Subject: Mine Ventilation Plan, Section 75.370, 30 CFR 75, Upper  
Big Branch Mine - South, I.D. No. 46-08436, Performance  
Coal Company, Montcoal, Raleigh County, West Virginia

This will acknowledge receipt of a revision to the ventilation plan, dated December 14, 2009, and submitted to this office December 16, 2009.

December 14, 2009

Re: Performance Coal Company  
Upper Big Branch Mine  
MSHA ID: 46-08436  
State ID: U-3042-92  
Ventilation Revision

# TYPICAL LONGWALL FACE VENTILATION

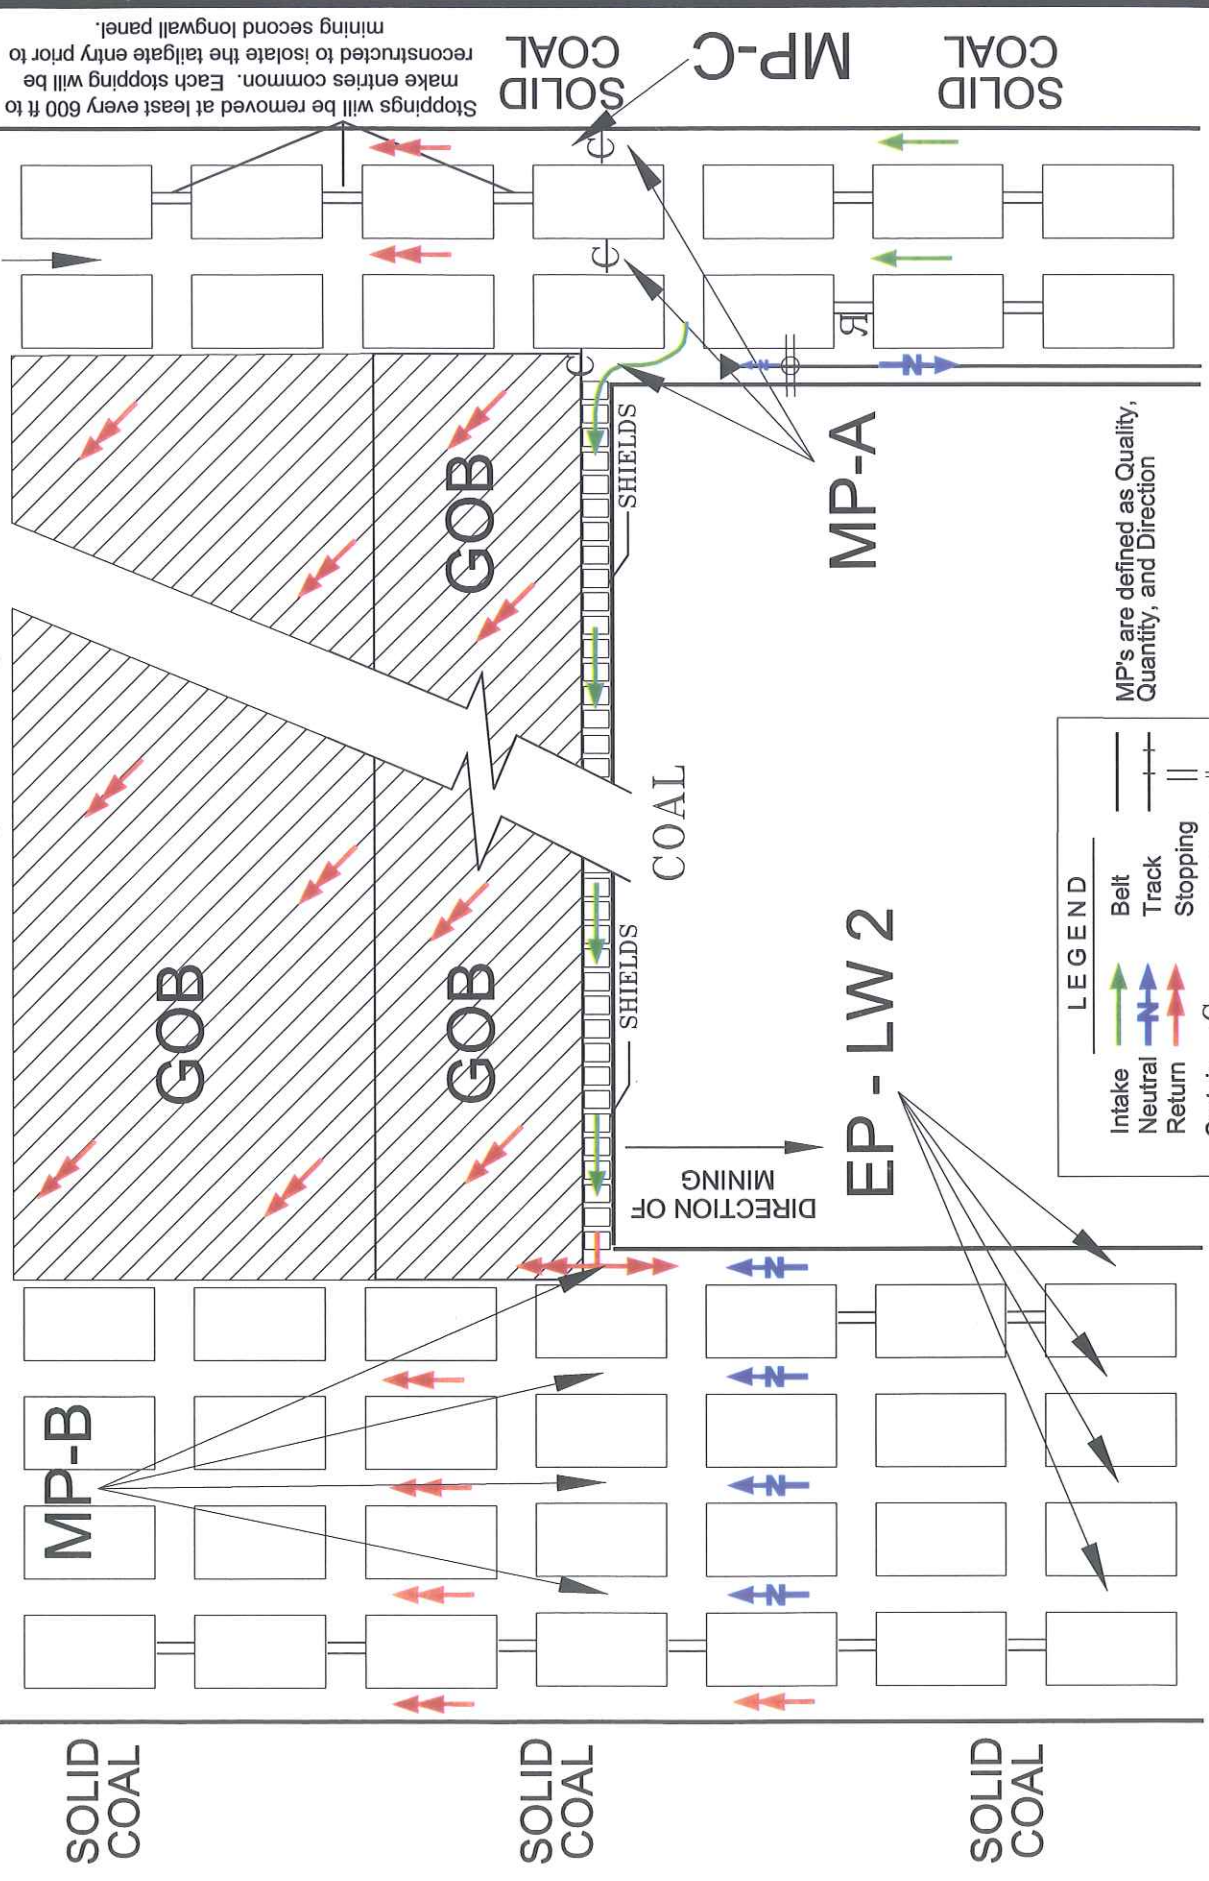
The ventilation revision requests to route a travelable return air course from the active MMU-029 into a common entry with MMU-040; make the #3 headgate entry a common intake air course with the existing primary escapeway; add a regulator to the overcast at the #1 Crossover on Headgate 1 North to allow the belt air to be reversed away from the longwall face; provide dewatering information; and project a future gateroad. A face sketch depicting mining Headgate 2 North with the belt line in #1 entry being ventilated with neutral air is included in the ventilation revision. In addition a face sketch is included depicting the typical longwall face ventilation for the No. 1 North Panel.

A drawing is attached showing the controls to be removed and installed for this revision. The return off of MMU 029-0 will be routed down the left side of North Glory Mains where it will cross overcasts on Headgate 1 North and be sent up Tailgate 1 North to the return shaft. The previous return entry will be made common with the belt along the #2 Crossover and with the longwall intake along Headgate 1 North. EP-LW1, MP A, and MP@X-Cut36 will now include the #3 entry. A regulator will be added in the overcast at the #1 Crossover on Headgate 1 North. This will allow the belt air to be reversed away from the longwall face. A typical longwall face sketch is included showing this change.

This revision is hereby approved and will be made a part of the approved plan for this mine. This approval is limited to the requested change as described in the submittal letter and shown on the attached map of the subject mine. **All ventilation changes will be made in accordance with 30 CFR 75.324.**

Please note, a second longwall panel will not be possible if the condition of the third entry of the #1 headgate cannot be maintained in adequate condition to comply with the requirements of 30 CFR 75.384. 30 CFR 75.384 requires a travelable tailgate entry for both current and future longwall panels. Additionally, the currently approved ventilation base plan and this revision require isolation of the tailgate entry to

prevent the longwall tailgate travelway from being ventilated with air from the worked out area.
